# 1955 Corvette: Service Bulletin: Hard Shifting

<b>CHEVROLET—CENTRAL OFFICE</b> DIVISION OF GENERAL MOTORS CORPORATION DETROIT 2, MICHIGAN	
<b>TECHNICAL SERVICE BULLETIN</b> Service and Mechanical Department	
<b>SUBJECT:</b> HARD SHIFTING - 1955 MODEL PASSENGER CAR 3-SPEED TRANSMISSION	<b>BULLETIN No.</b> DR #236  <b>SECTION</b> VII
<b>TO:</b> ALL CHEVROLET DEALERS	January 9, 1956
<p>In cases where hard shifting on 1955 Passenger Models with 3-Speed Transmission is experienced in high frequency shifting operations due to malfunction and/or wear of gearshift controls and butting of transmission gears, the condition may be reduced by installation of a Transmission Control Conversion Kit and three new type transmission gears.</p> <p>The new transmission gears which have more tooth chamfer entered production about July 5, 1955.</p> <p>The revised transmission controls entered production beginning with 1956 Model and the Control Conversion Kit has modified parts for use on 1955 Models.</p>

FIGURE I

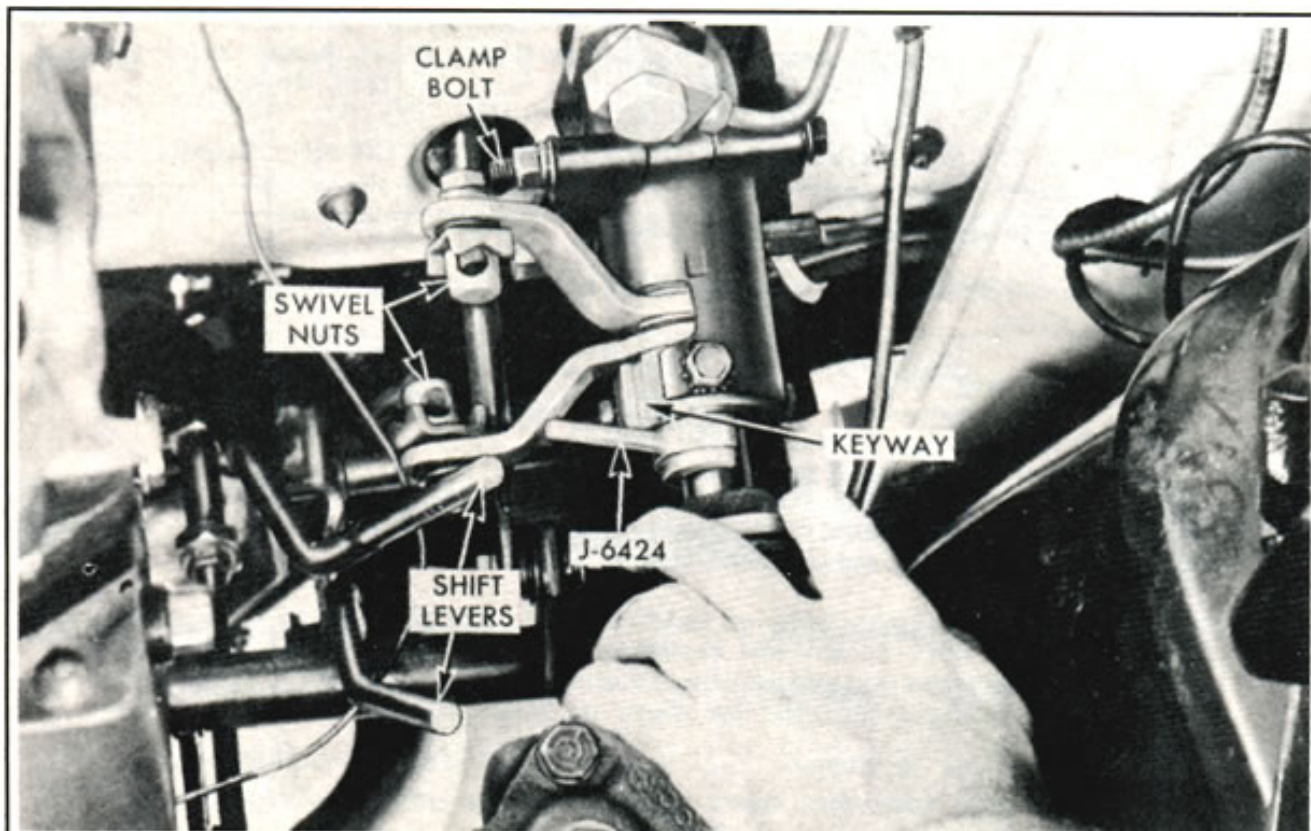
13. Insert gearshift rod ends in swivels - transmission must be in neutral detent in both ranges. Do not tighten.
14. Install alignment gauge J-6424 inserting side stamped "STD" between steering mainshaft and shifter tube in key area. This sets the required 1/16 eccentricity in proper relation to the key on shifter tube. See figure 1.

FIGURE 2

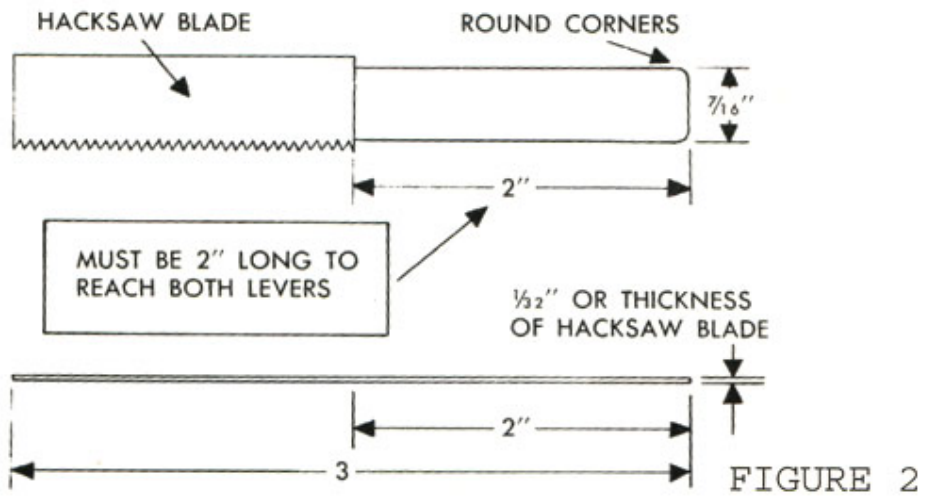
- c. Remove alignment gauge.
16. Make and insert special blade gauge, see figure 2, thru adjusting ring slot, lower levers and gate washer. Tighten swivels on gearshift rods while holding downward lightly on lower levers. Transmission must be in neutral detent at this time.

FIGURE 3

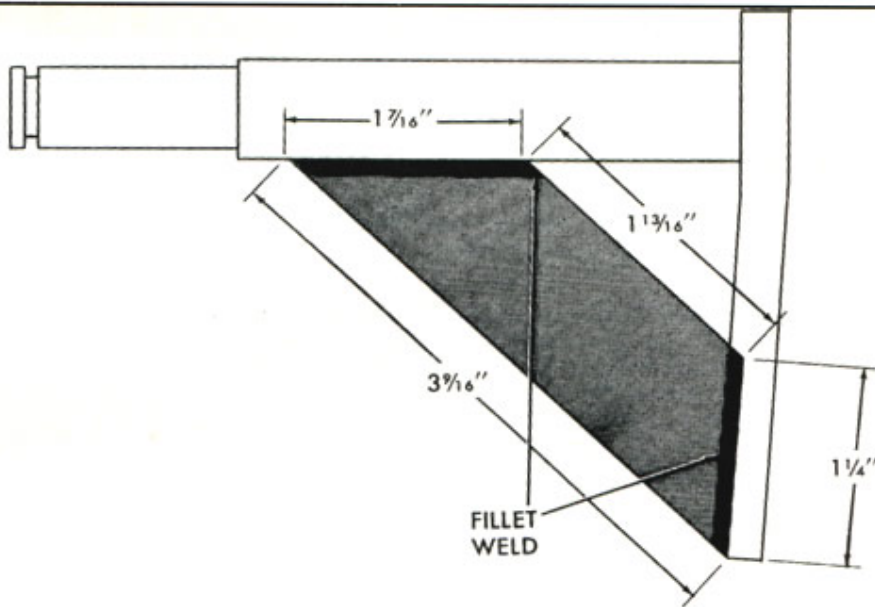
Further improvement of shifting can be made by reinforcement of transmission control rod idler lever support located on left frame rail under toe pan to reduce its deflection. See figure 3.
